Submissions Report

19-25 Balfour Street, Lindfield
In -fill Affordable Housing
SSD 82709458

Prepared for Balfour Group Pty Ltd

Submitted to DPHI

Figure 3 3D (Southwest) of height plane (Source: Giles Tribe)

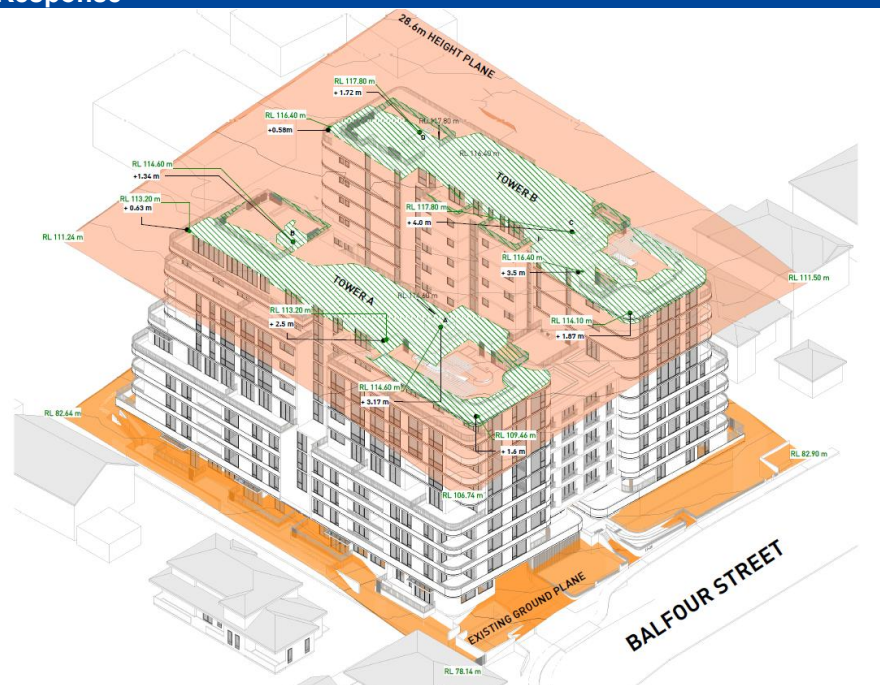
Summary of Submissions	Response
	 Figure 2 Indicative Future Development (Source: Giles Tribe)
<i>Q Insufficient Information to Undertake an Assessment</i> <i>a) The elevations and sections do not sufficiently identify existing ground RL's.</i> <i>b) The roof plan should include the survey spot height and contours to demonstrate maximum building height.</i> <i>c) The use of all areas should be labelled and the plant areas to be particularised showing what plant is proposed.</i> <i>d) The location of the external clothes drying areas for the apartments must be detailed on the plans. If these areas are located on the balconies, they are to be appropriately screened and excluded from private open space calculations.</i>	• The updated scheme is supported by an updated Architectural Plans (Appendix 6). • These have included a height plane diagram that's identified the existing ground plane to address the site sloping topography. • The developments height exceedance has been reduced and centralised to the upper levels of the development and should be not visible from the street. • A 3D view from the Southwest is included below:

- The roof floor plans include the exact use and plant equipment located at the roof elements.
